Issue	Date	Event
A	04.08.22	Issue for Section 4.55

Project
28 Lockwood Avenue, Belrose

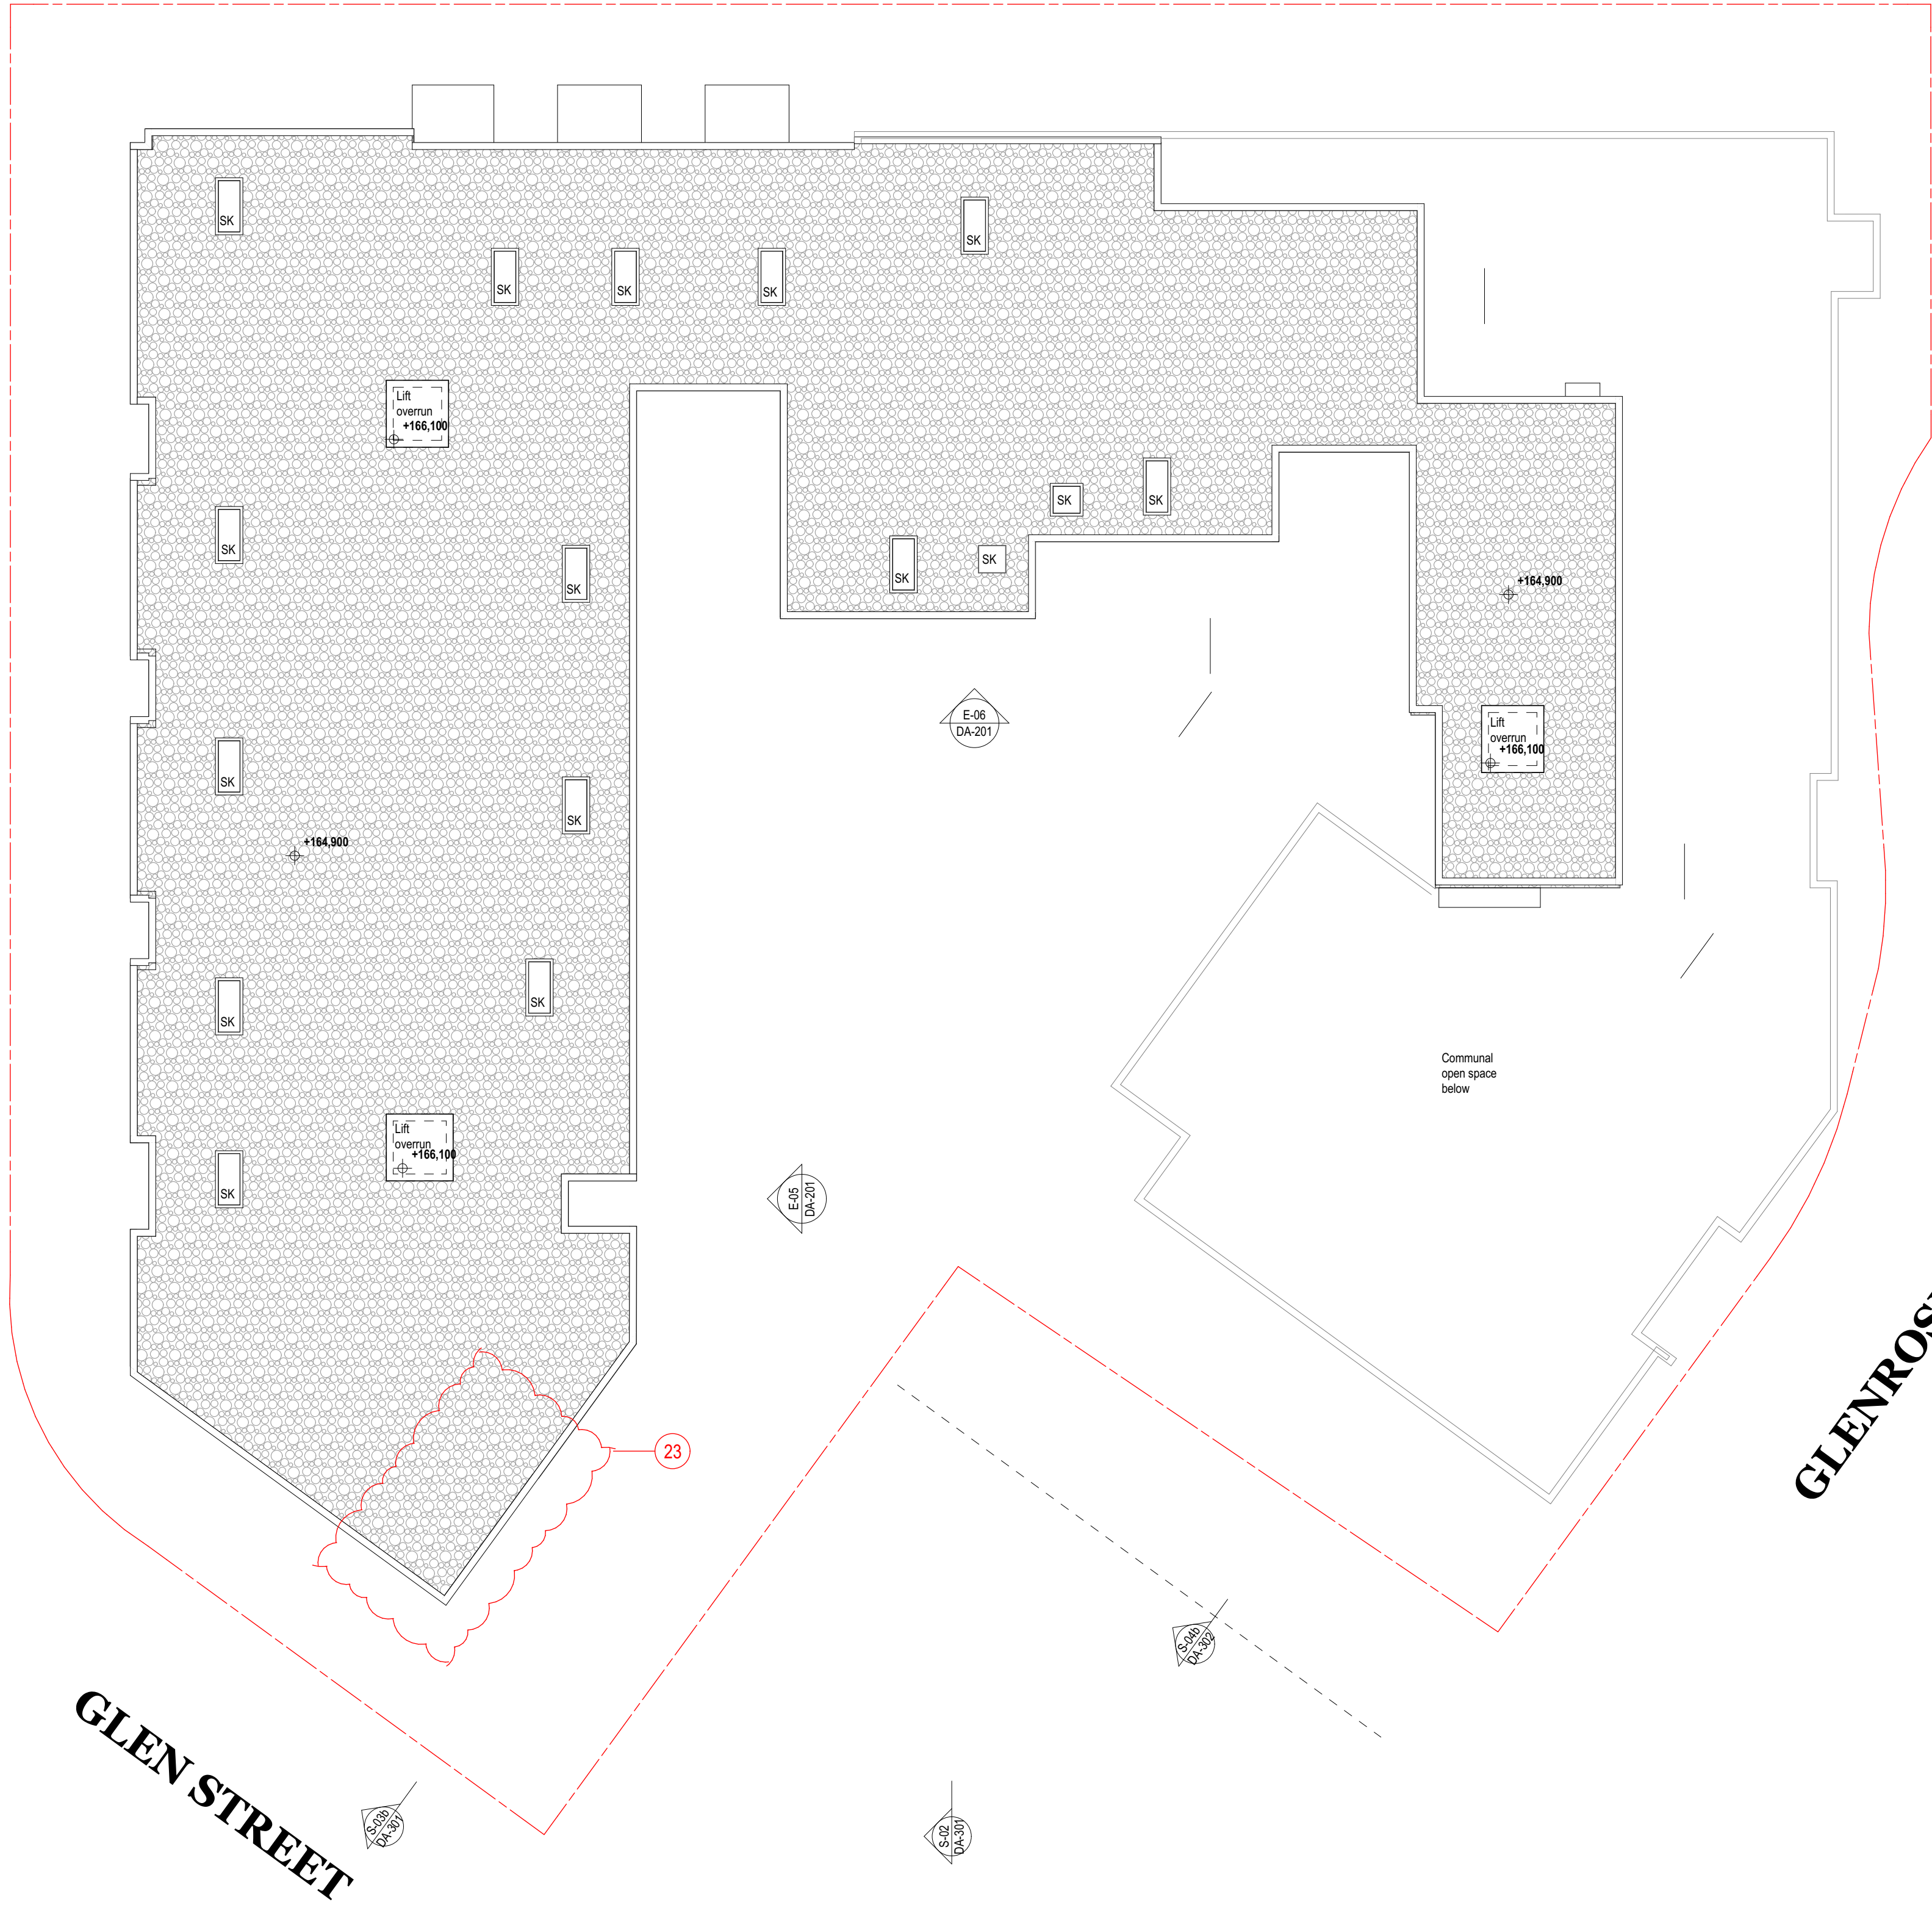
- 1- Entry and exit ramp combined and relocated.
- 2- Traffic flow, car spaces and storage cages rearranged.
- 3- Floor RL lowered.
- 4- EOT and accessible bathroom relocated.

- 5- Fire stairs relocated to comply with NCC.
- 6- Plant and utility rooms rearranged.
- 7- Loading dock entry/exit ramp modified.
- 8- Accessible bathroom provided

- 9- Glenrose pl pedestrian entry ramp and steps modified.
- 10- levels modified.
- 11- Entry to shop number 07 modified.
- 12- Mechanical exhaust shafts located.

- 13- Loading dock RL modified.
- 14- Face brick removed from intermediate exposed slab edges.
- 15- Proposed clubhouse/communal room.
- 16- Fire stairs relocated and minor internal unit rearranged adjacent to the new stair location.

- 17- Glen street pedestrian entry modified for structural rationalisation.
- 18- Electrical switch boards located.
- 19- External wall modified.
- 20- Unit 1.01: East wall relocated, balcony deleted.

- 21- Waste lift is changed to Retail lift and it drops to basement 04.
- 22- The hoist lift in the loading dock is changed to waste lift and it drops to basement 03.

- 23- Roof extended over enclosed balcony.
- 24- Internal layouts modified for more efficient, spatial use and relationship:
LG01, LG02, LG06, LG10, LG12, LG14, LG15, LG18.
G01, G02, G05, G09, G13, G15, G16.
L1.02, L1.05, L1.08, L1.12, L1.13, L1.14
The amendments for the following units are subject to section 4.55 application:
LG03, LG05, LG07, LG08, LG09, LG11, LG13, LG17, G03, G06, G08, G10, G11, G12, G14, L1.01, L1.03, L1.04, L1.09, L1.11.

- 25- New aluminum windows and doors.

SECTIONS

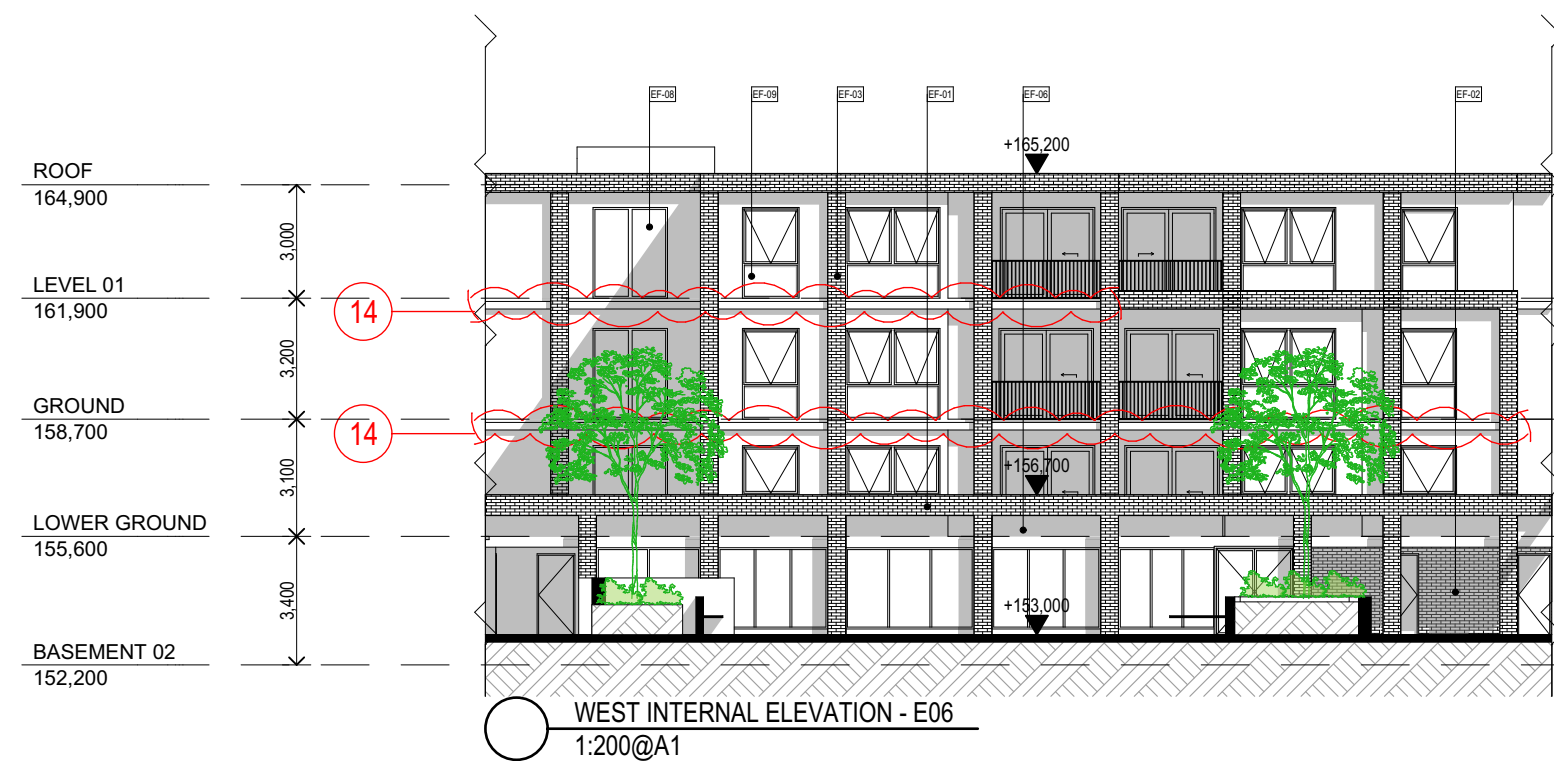
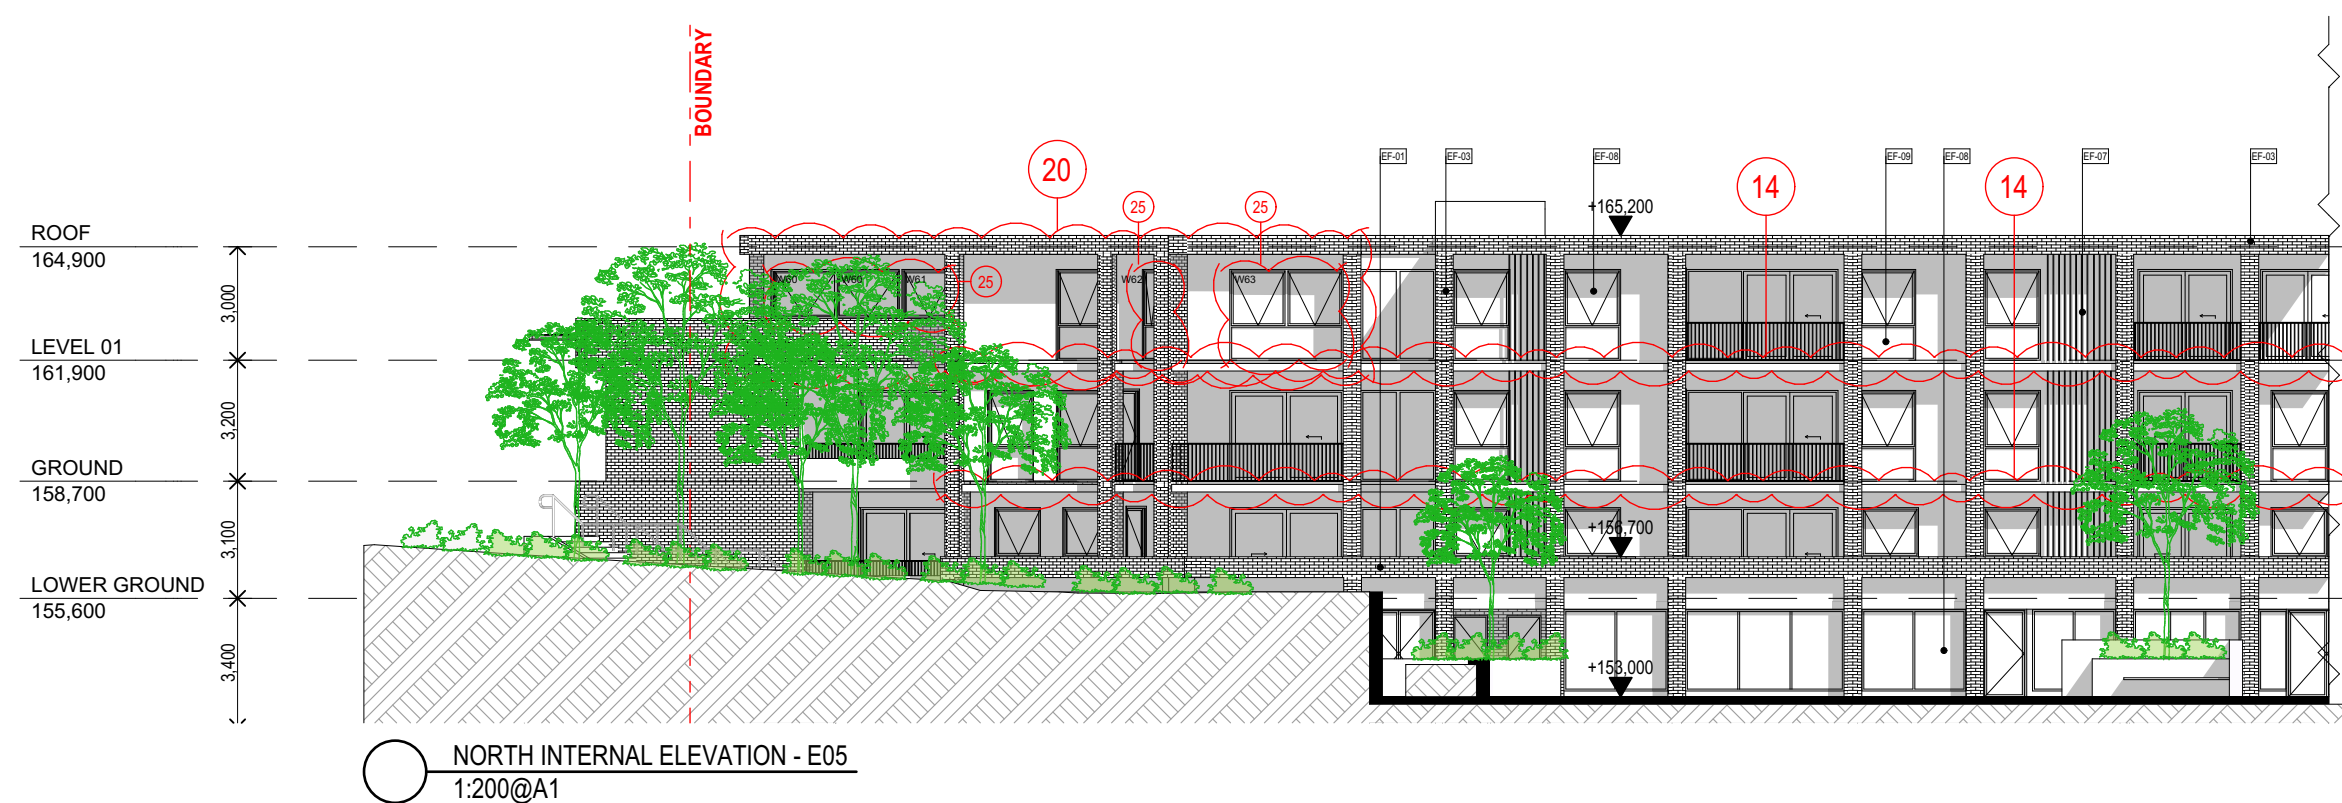
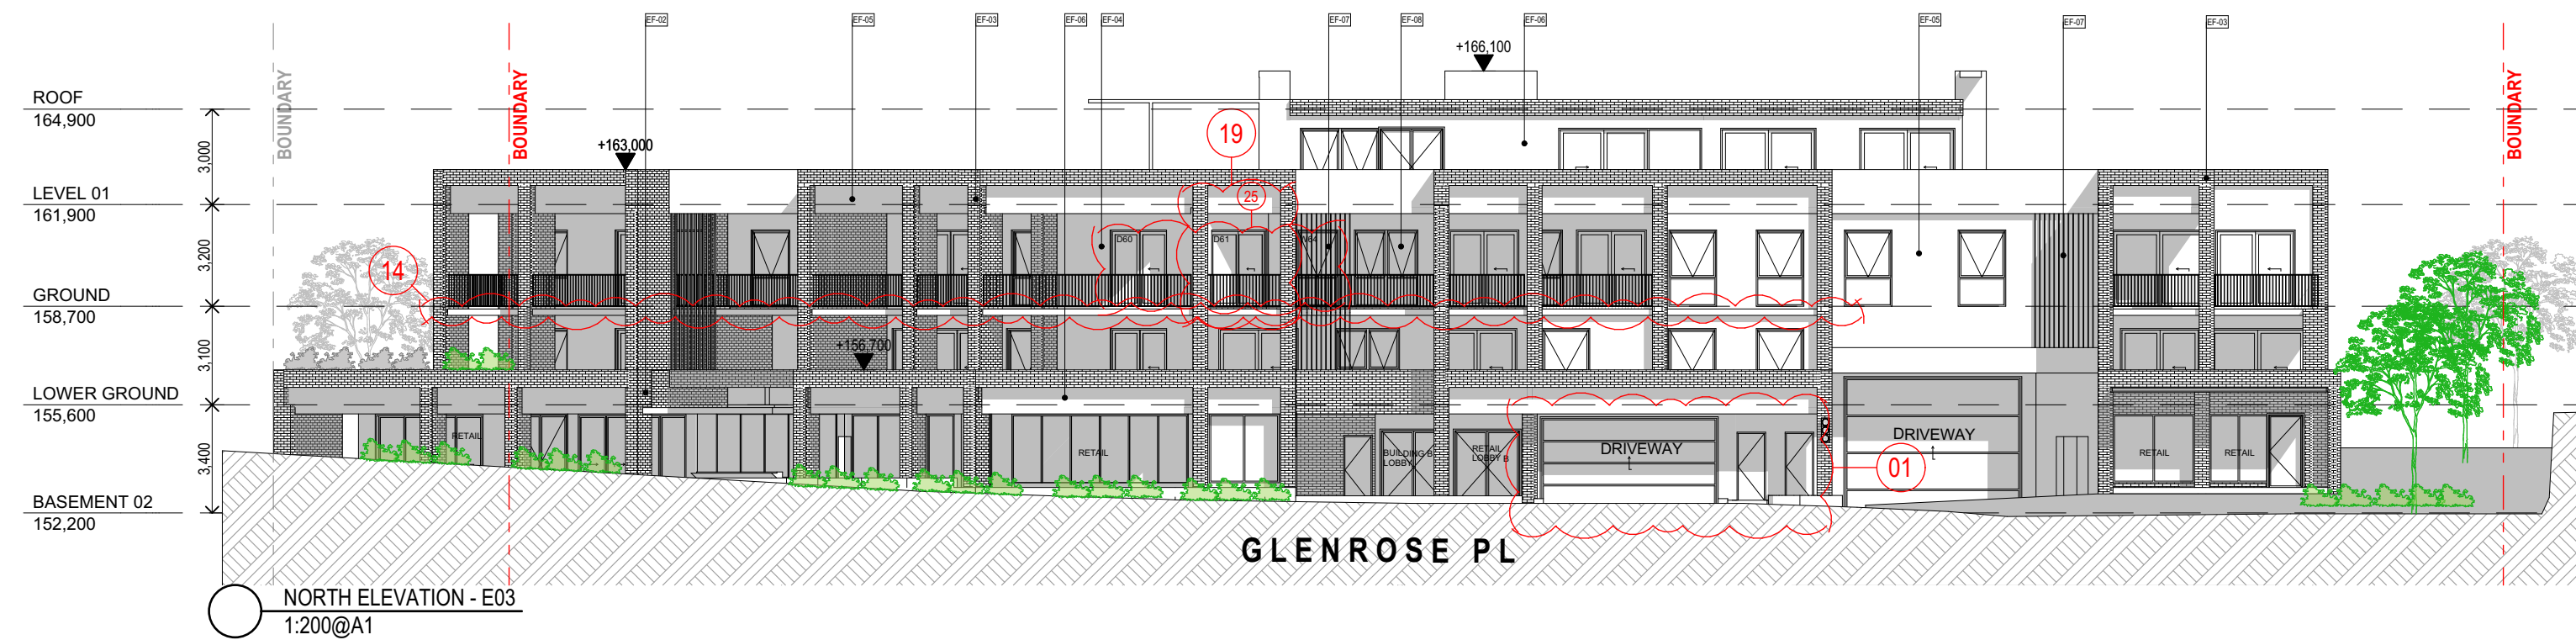
- Entry and exit ramp combined and relocated.
- Traffic flow, car spaces and storage cages rearranged.
- Floor RL lowered.
- EOT and accessible bathroom relocated.

- Fire stairs relocated to comply with NCC.
- Plant and utility rooms rearranged.
- Loading dock entry/exit ramp modified.
- Accessible bathroom provided
- Glenrose pl pedestrian entry ramp and steps modified.

- Levels modified.
- Entry to shop number 07 modified.
- Mechanical exhaust shafts located.
- Loading dock RL modified.
- Face brick removed from intermediate exposed slab edges.

- Proposed clubhouse/communal room.
- Fire stairs relocated and minor internal unit rearranged adjacent to the new stair location.
- Glen street pedestrian entry modified for structural rationalisation.

- Electrical switch boards located.
- External wall modified.
- Unit 1.01: East wall relocated, balcony deleted.
- Waste lift is changed to Retail lift and it drops to basement 04.

- The hoist lift in the loading dock is changed to waste lift and it drops to basement 03.
- Roof extended over enclosed balcony.
- Internal layouts modified for more efficient, spatial use and relationship:
LG01, LG02, LG06, LG10, LG12, LG14, LG15, LG18.
G01, G02, G05, G09, G13, G15, G16.
L1.02, L1.05, L1.08, L1.12, L1.13, L1.14
The amendments for the following units are subject to section 4.55 application:
LG03, LG05, LG07, LG08, LG09, LG11, LG13, LG17, G03, G06, G08, G10, G11, G12, G14, L1.01, L1.03, L1.04, L1.09, L1.11.

- New aluminum windows and doors.
